**SECURE DOCUMENT STORAGE FACILITY
BAGHDAD, IRAQ**

SUSTAINMENT ASSESSMENT

**SIGIR PA-08-166
OCTOBER 20, 2009**

Figure 1. Strengthening columns

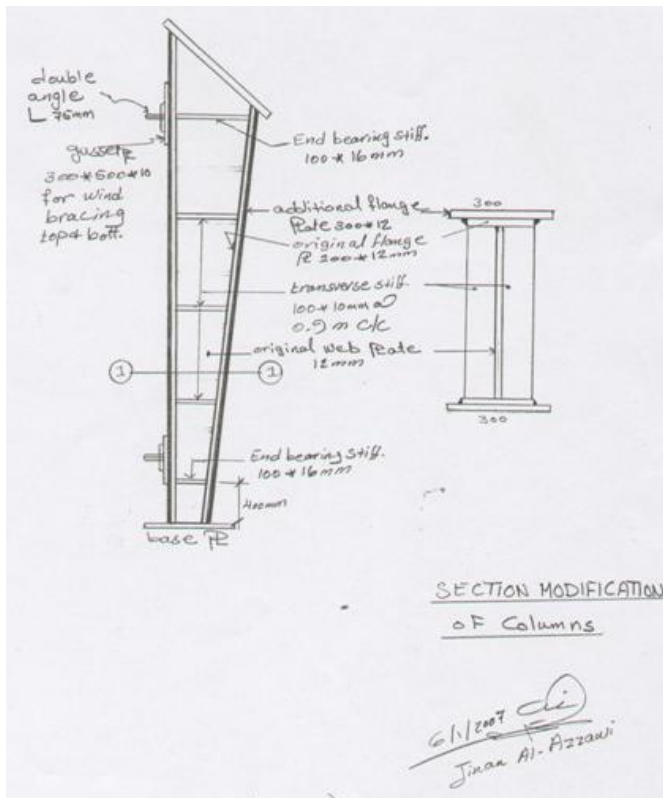
After the December 2006 structural failure, the contractor performed an evaluation and proposed a revised design in January 2007. Specifically, the contractor proposed reinforcing the structure to accommodate the design deficiencies. The proposed solution consisted of the following:

- adding coverplates and stiffeners to the steel frame (Figure 1)
- placing collar ties at each frame
- adding an additional column at the center of each frame
- providing a lateral-load resisting system for the structure (Figure 2)

Figure 2. Additional bracing

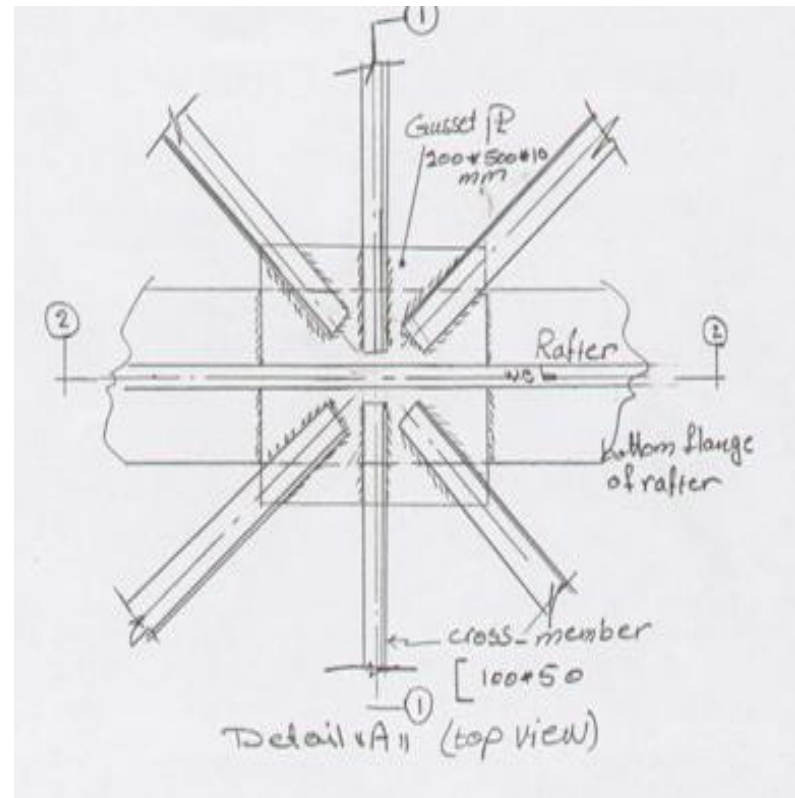
It appeared that the additional reinforcement addressed the structural issues with the main steel framing; however, the additional support columns may have created issues with the other structural elements. The initial design calculations do not appear to include the additional load from the steel framing. Since the bay spacing¹¹ for the metal building does not align with the column spacing for the reinforced-concrete beam, the additional steel support columns are located at various points along the reinforced-concrete beam span. This lack of alignment creates additional bending and shear in the concrete beam. No additional calculations were provided to determine if the reinforced-concrete beam has adequate capacity to carry the additional load from the steel framing.

Figure 3. Three-dimensional model of contractor-proposed improvements (Courtesy of GRC)

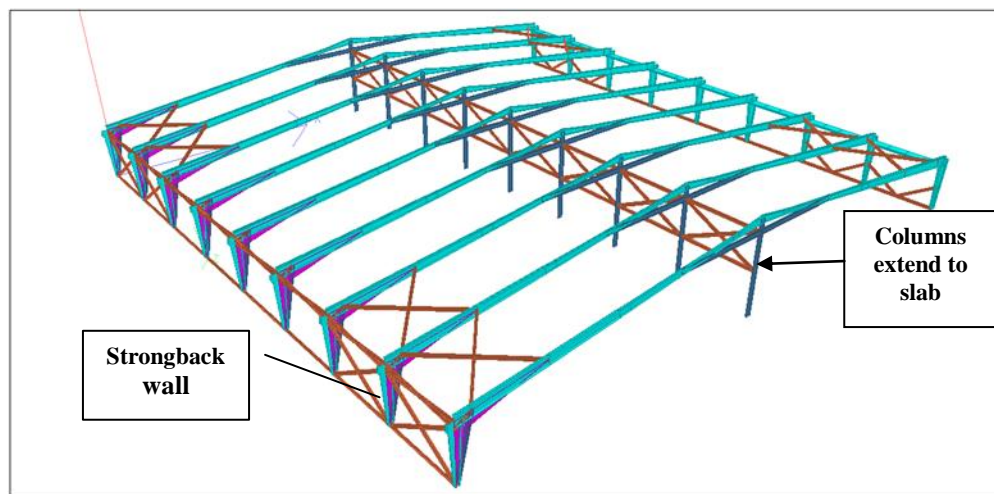
The contractor provided a revised design submittal in January 2007 to correct the design deficiencies that led to the structural failure. In July 2007, the GRC quality assurance (QA) representative documented examples of the building not being constructed in accordance with the planned structural improvements of January 2007. On 26 July 2007, a GRC structural engineer performed an inspection of the construction to date. The GRC structural engineer issued an observation report, which identified several construction deficiencies; all structural work again stopped while the contractor performed another structural evaluation. In September 2007, the contractor presented GRC with structural improvements, including a structural analysis indicating that the proposed improvements would provide a stable structure under eight different loading conditions. The proposal included a row of columns to be constructed along the centerline of the facility, as well as other strengthening improvements, such as corner bracing, cross bracing, and a strongback¹³ wall (Figure 3).

Figure 3 illustrates the proposed new steel columns along the centerline, extending to the floor. However, by this time, the interior vault rooms had already been constructed, including a reinforced-concrete beam and partition wall running the length of the building, beneath the centerline of the steel frames. Based upon review of the October 2007 QA reports, it appeared that the contractor performed a modified approach to placing the columns. A base plate was placed on the top of the reinforced-concrete beam, and the columns were welded to the base plate (Site Photo 3). Consequently, this model and corresponding structural analysis do not account for the additional load to the reinforced-concrete beam, supporting columns, and foundation.

Figure 4. Poured concrete columns within block wall (Courtesy of GRC)

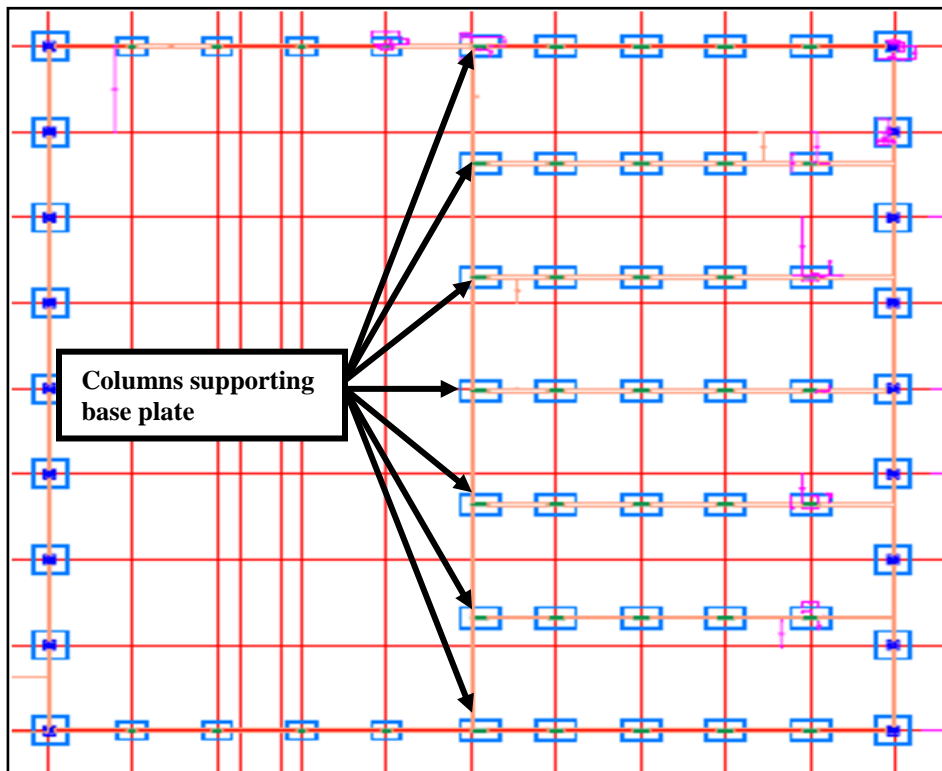
A concrete masonry partition wall is located beneath the reinforced-concrete beam (Figure 4). If the reinforced-concrete beam deflects under load, some load sharing between the beam and the wall will occur. Reviewing the daily QA reports, SIGIR identified that the blocks used to create this wall were of poor quality, which by themselves, would be of questionable capacity to hold any significant load. The presence

of the beam indicates that the original designer did not anticipate the wall to be a structural element.

**Site Photo 15. Contractor replaced previously cracked and buckling floor tiles
(See Site Photo 8 for original condition of bathroom floor.)**

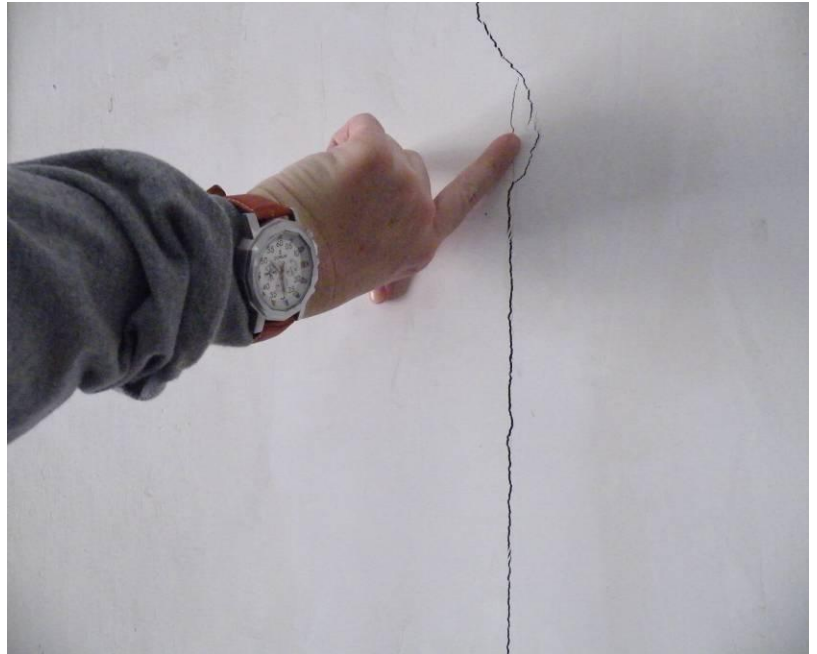
However, during the 27 September 2009 site visit, SIGIR toured the entire facility and determined that the contractor had remedied the previously identified warranty deficiencies (Site Photo 15). The SDSF facility manager stated that the GRC IZ Resident Office did an excellent job of requiring the contractor to return to the facility three times to ensure that each warranty issue was adequately addressed.
